Some Questions and issues arising from the operation and maintenance of NEXT-100

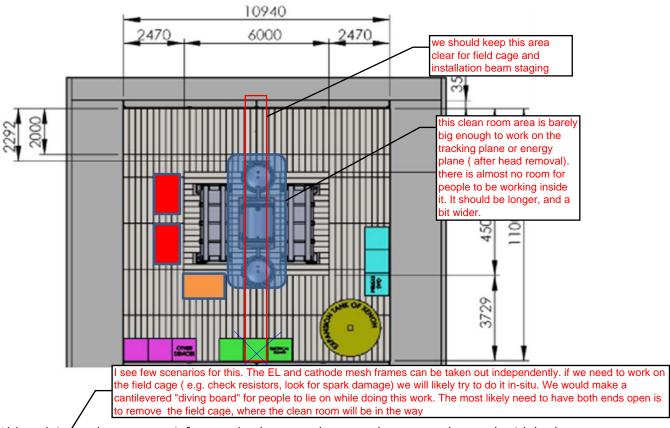
if we run a gas purge on the vessel before separating the heads, we can then open the heads up enough to insert a cover plate over the vessel flanges, then the heads can be removed and bagged if needed, we can then erect the clean room over the vessel, no?

Ideally as much as possible, but given the location of the shielding walls, the best would be to have the curtains on the inside of the walls. Usually the dimensions of these areas can be adjusted to 50cm, therefore I would suggest a room of approx. 5000x2000 mm2 (based on the dimensions given in the drawing) as you can see on the sketch.
